**ADDENDUM TO THE APPLICATION FOR AN
ENVIRONMENTAL ASSESSMENT CERTIFICATE
FOR THE PROPOSED
FORTISBC ENERGY INC.
EAGLE MOUNTAIN – WOODFIBRE GAS PIPELINE PROJECT**

**September 2015
492434
Addendum 3
Rev. 0**

FIGURE 1.1-2
APPLICATION CORRIDOR
EXPANSION AND
PROPOSED MOUNT MULLIGAN
FACILITY SITING AREA
EAGLE MOUNTAIN - WOODFIBRE
GAS PIPELINE PROJECT
ADDENDUM NO. 3

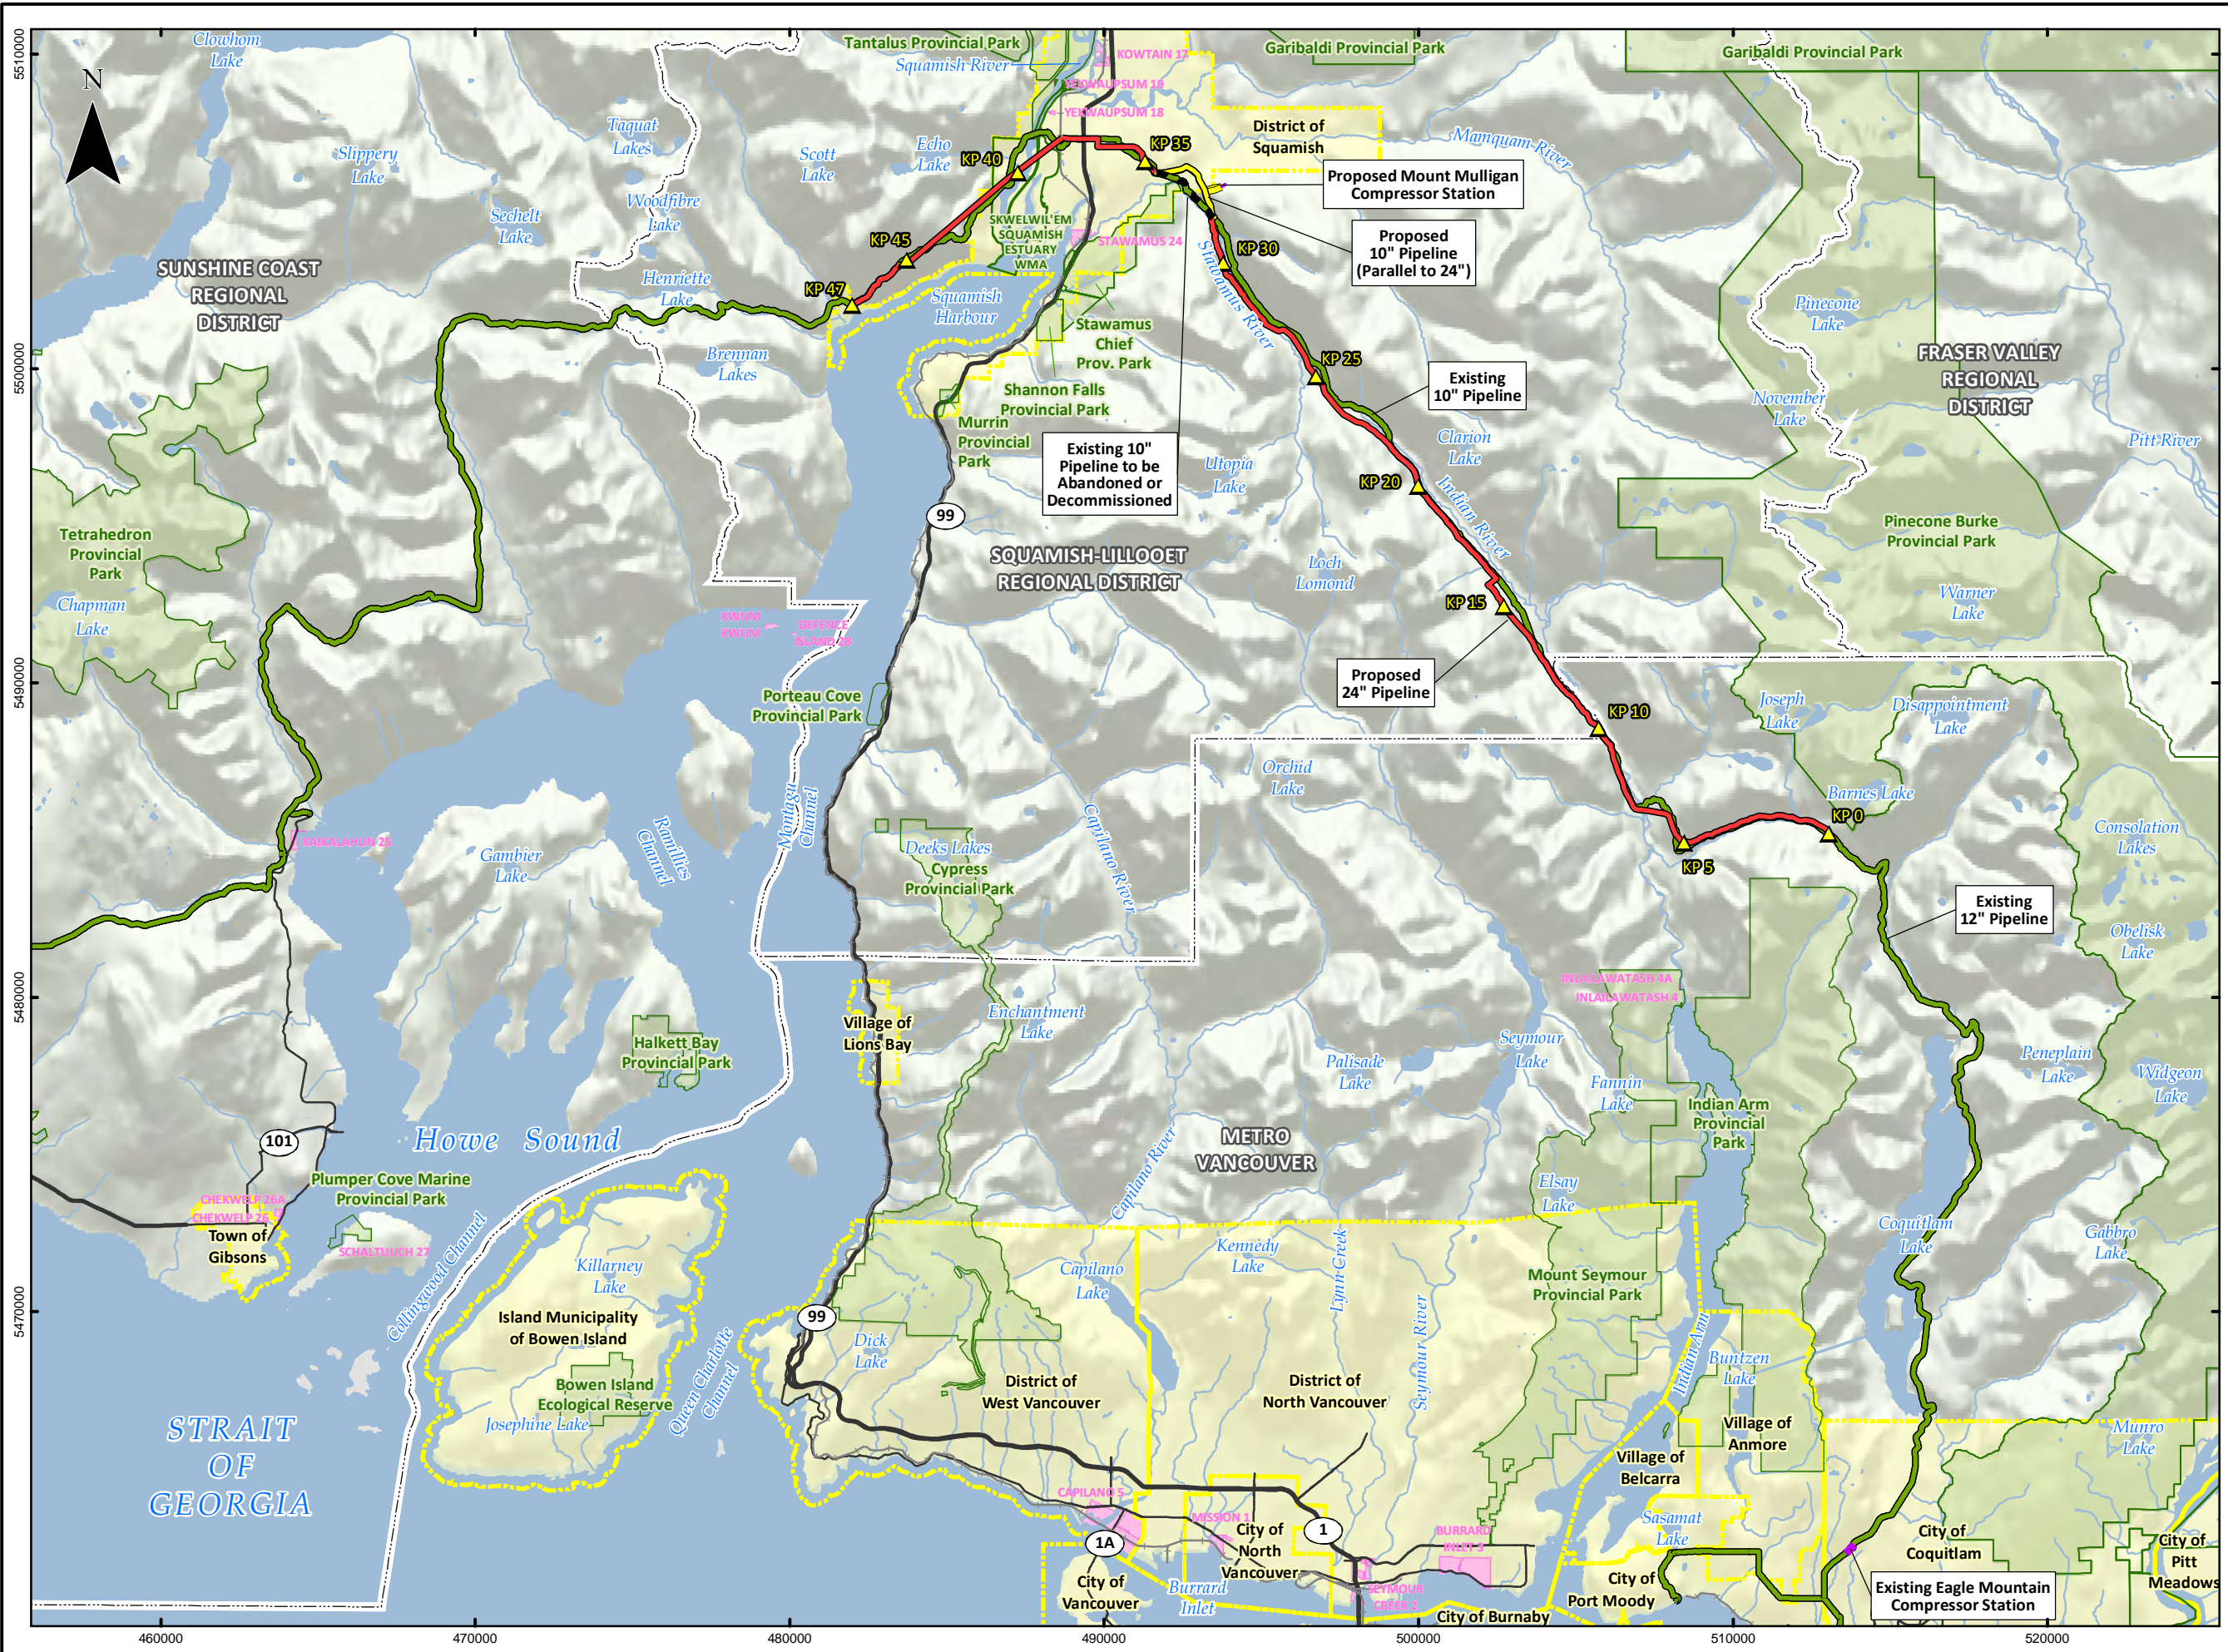
An overview of the proposed Project location is provided in Figure 1.1-1. An overview of the preliminary Mount Mulligan compression station site, Facility Siting Area, Application Corridor expansion and abandoned NPS 10” section is provided in Figure 1.1-2. An overview of the change in footprint for the Eagle Mountain compressor station upgrade is provided in Figure 1.1-3.

FIGURE 1.1-3

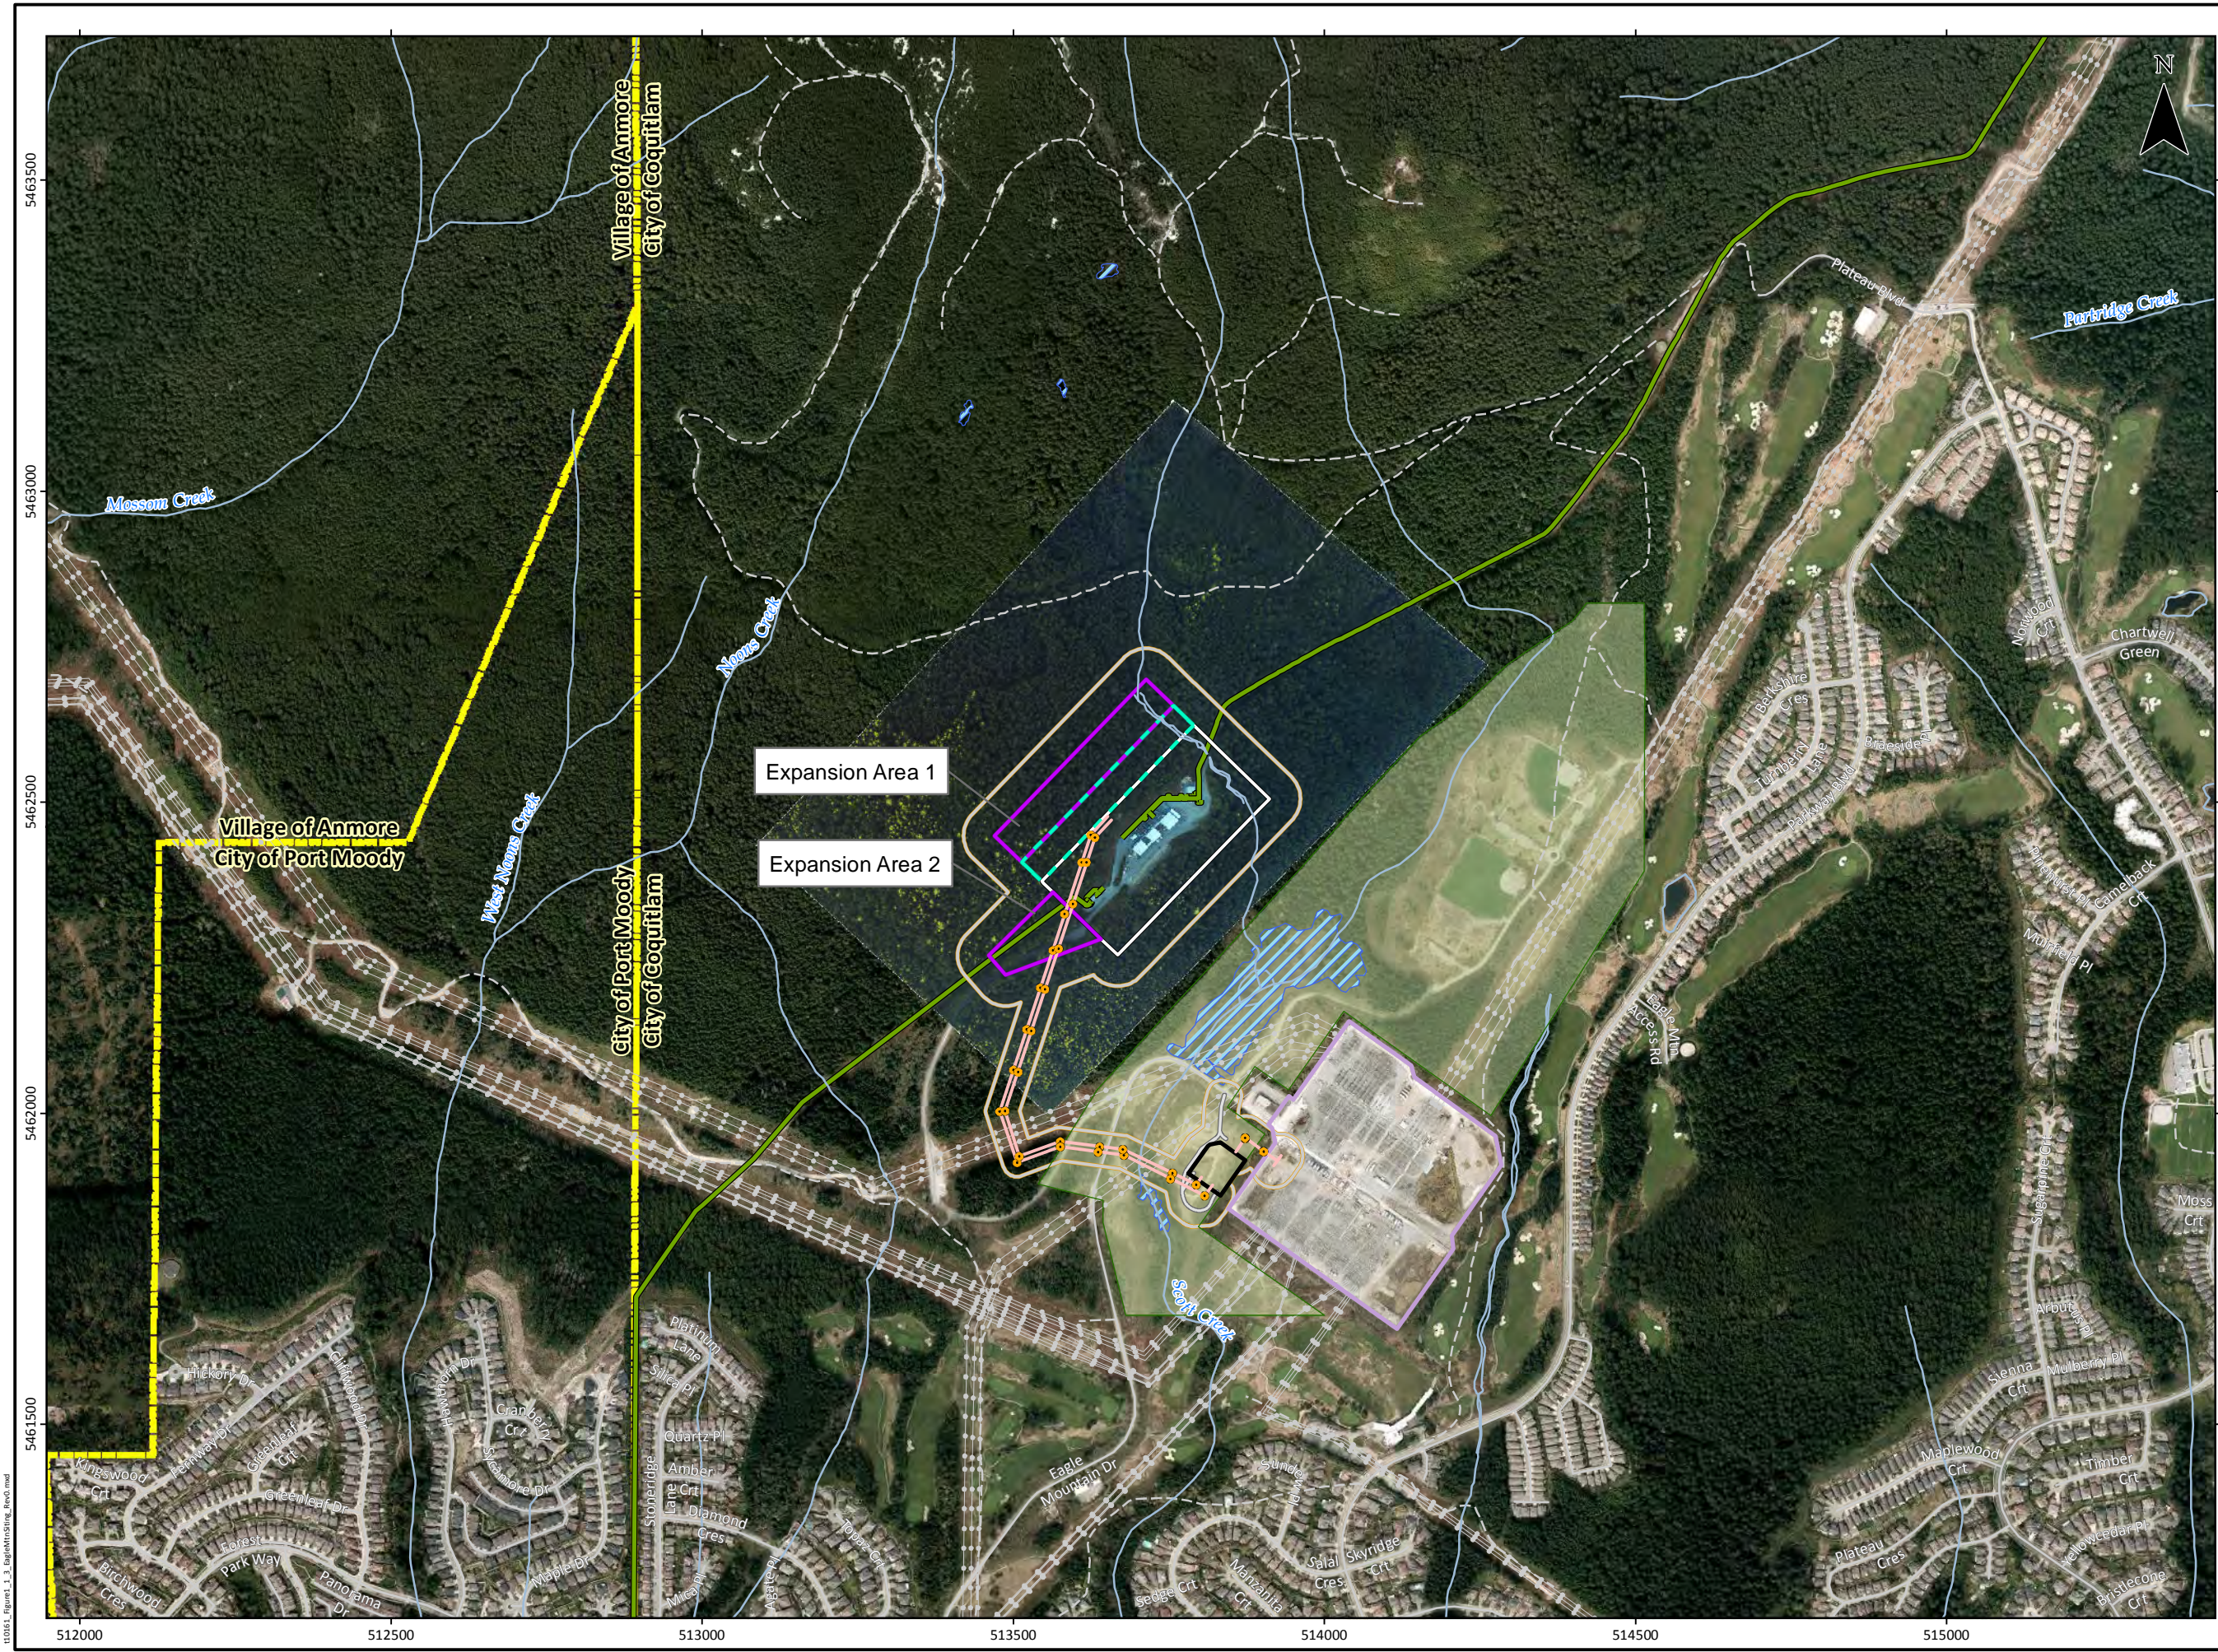
- removal of the Port Mellon upgrades due to an optimization in compression design;
- a change to the footprint of the Eagle Mountain compressor station to accommodate a shift in workspace;

- Notes: 1 The abandonment KPs are for the existing FortisBC pipeline and do not match the KPs for the proposed Project.
 2 Refer to Figure 1.1-3 for Area 1 and 2 of the Eagle Mountain compressor station footprint.
